Buildings - South Kanara - Hosangadi Police lines - Constructing a well - Unprofitable outlay - written off.

*Subject:-- Collapse of the well in the Hosangadi Police lines, South Kanara District.

In forwarding herewith the report received from the Executive Engineer, West Coast Division regarding the collapse of the well in the Hosangadi Police lines, South Kanara District I request you will be good enough to obtain sanction of Government to the unprofitable outlay of Rs.955-7-0 spent on the work.

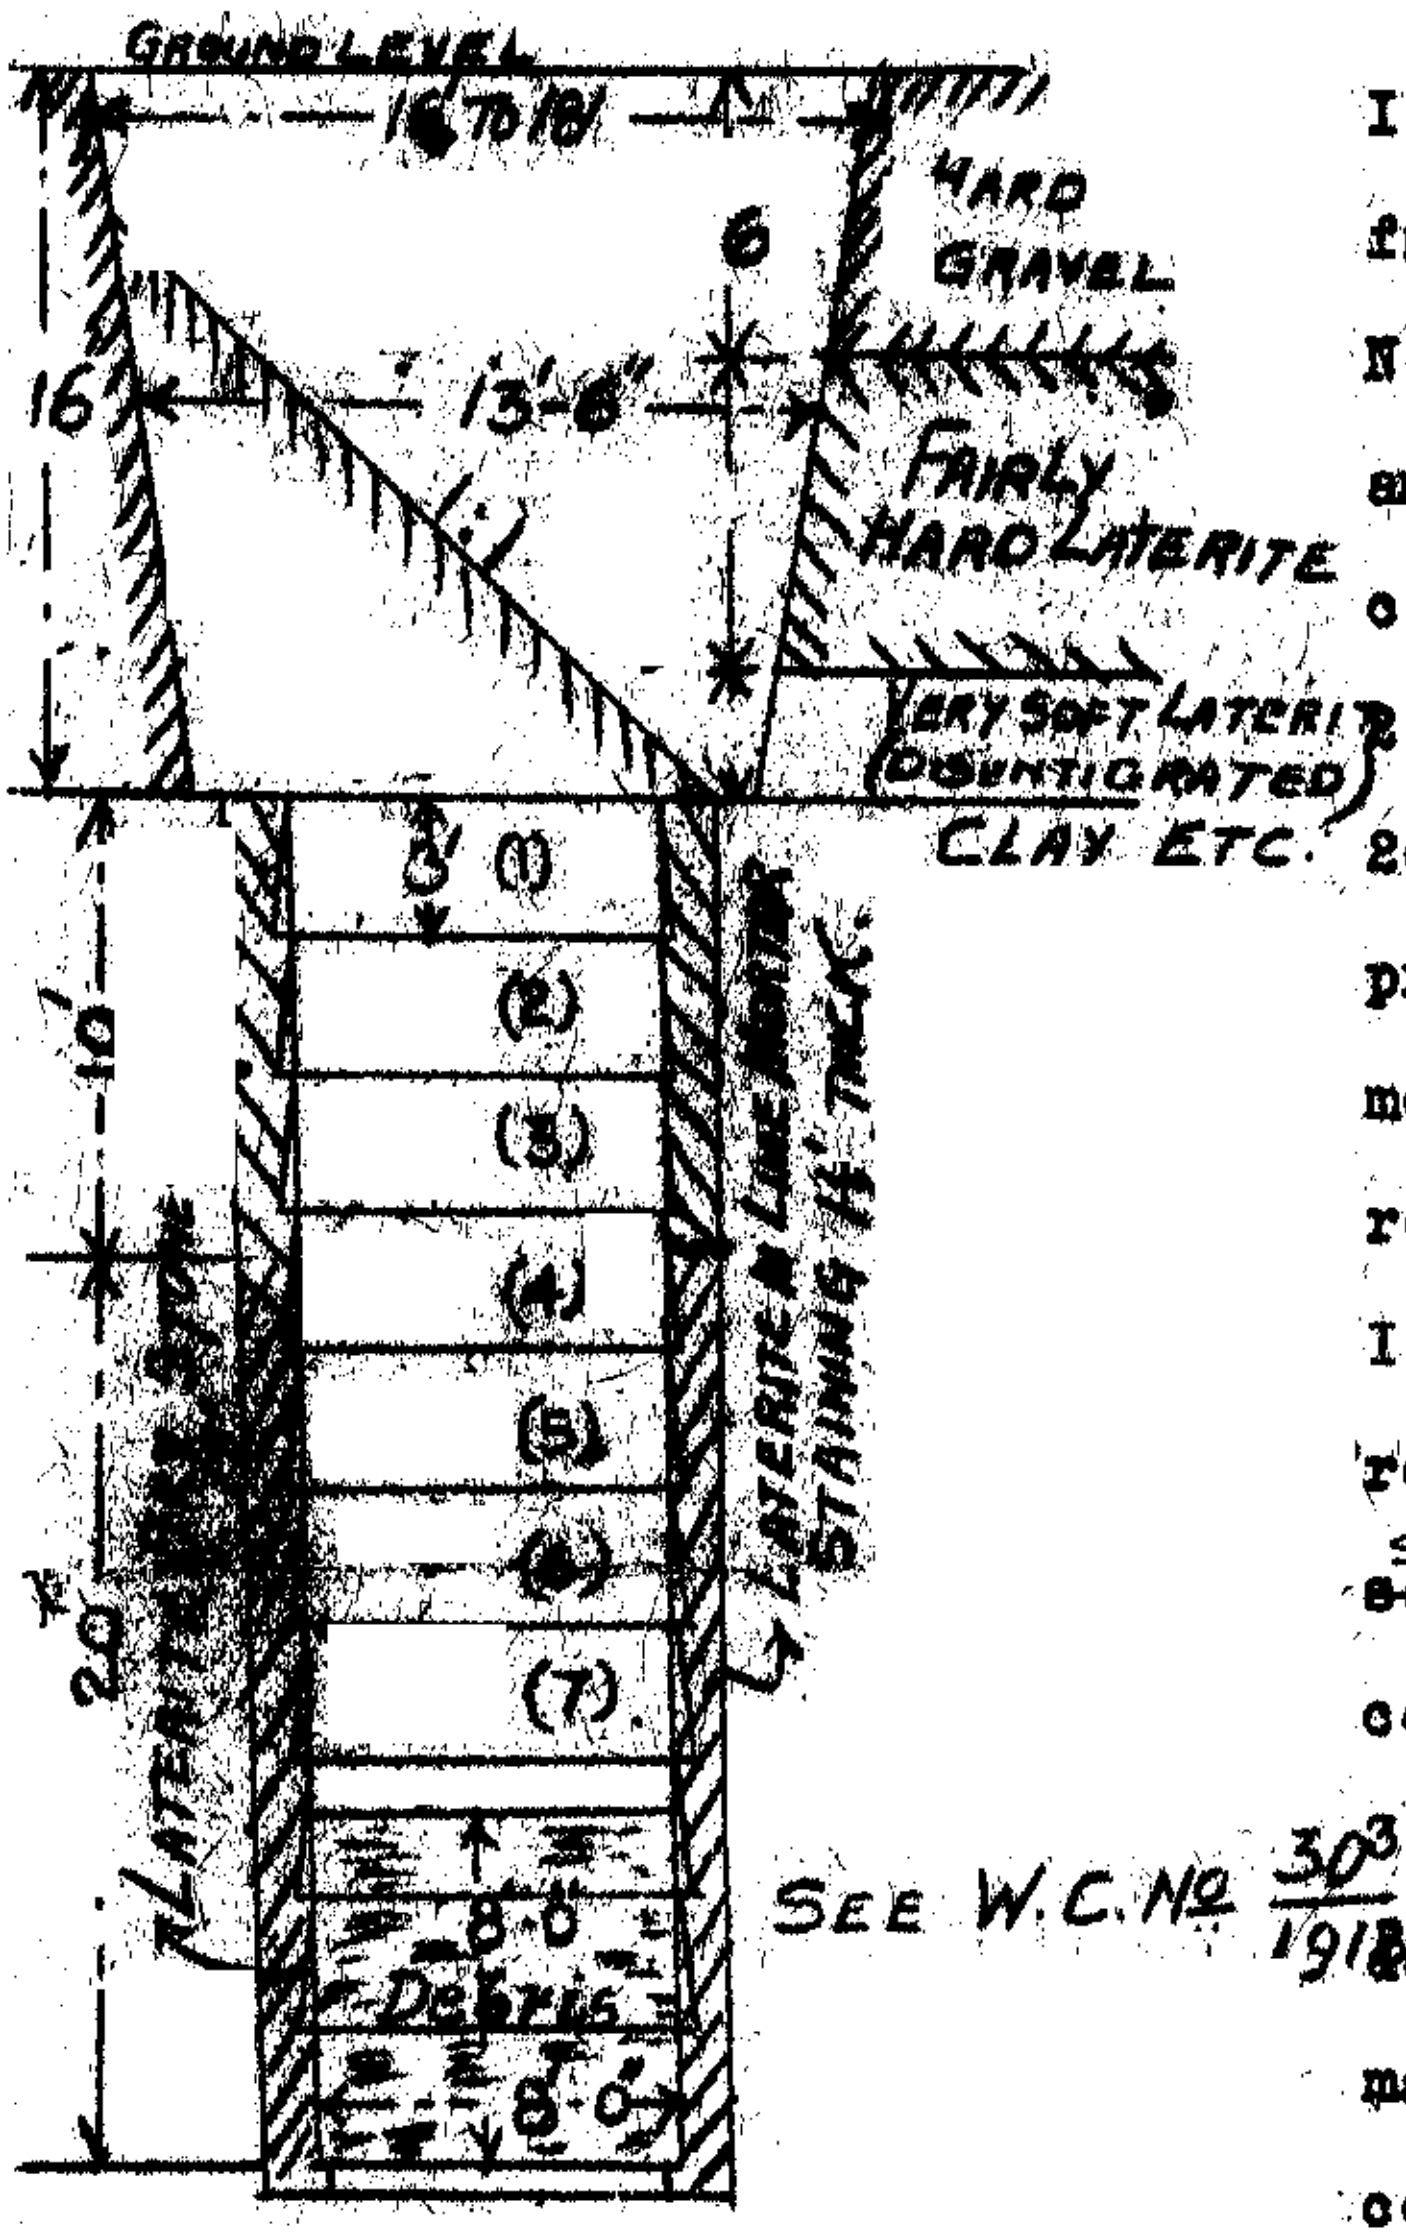
3. On 11-5-22 ~~E~~ I had observed the debris standing in well as shown in the marginal sketch, and that my predecessor could not have fully examined the steining except by shifitng the debris at A. I could therefore take my predecessor's report No.147 E dated 22-2-22 as final. I regret that his endorsememt to section officer of the above asking him to have the debris removed completely was not sent to him by this office until I observed and did it in No.473 S dated 10-4-22. The Section Officer did not realise the need for removing the debris ~~being~~ until I inspected the work on 11-5-22 when I insisted upon the debris being removed. It was very late in the season for rains had already commenced when I inspected the work again on 15-6-22 debris had been removed to 38' belww ground level and further work not being possible it had to be stopped. There is then still 8' of debris at bottom and the condition of the steining here is not knwon.

of which the top most 16' of latrite in mortar stening 1' thick collapsed into the well with the parapit and the platform. Below the first step two stretch was fallen half round for a height of 2'. 2nd and 3rd step in fact. 4th and 5th corroded half round for a depth of about 8" and height of 2'. 6th step corroded for a legth of 4' ~~on~~ height of 1'6" and depth of about 8".

Those corrosions were caused by the collapse of the masonry debris against the stening which got crushed by the fall. The circular shape of the well is in fact but I notice that a large percentage of stones are softened by the crushing collapse of the debris or due to the poor quality of the stone from the Jalda hadi quarry which had been selected for the work. Though an experienced well sinker tells me that the corrosions can be repaired and the stening will stand I consider it is no good trying to repair the well. A single weak stone will suffice to cause the collapse. Therefore I have had to provide for the full reconstruction of the well.

11. Since the reconstruction can be done only next year I request permission to close the present estimate and suggest the sanction of the separate estimate for the reconstruction for which an abstract estimate is submitted. Early sanction is requested so that stones may be got quarried early and collected for drying.
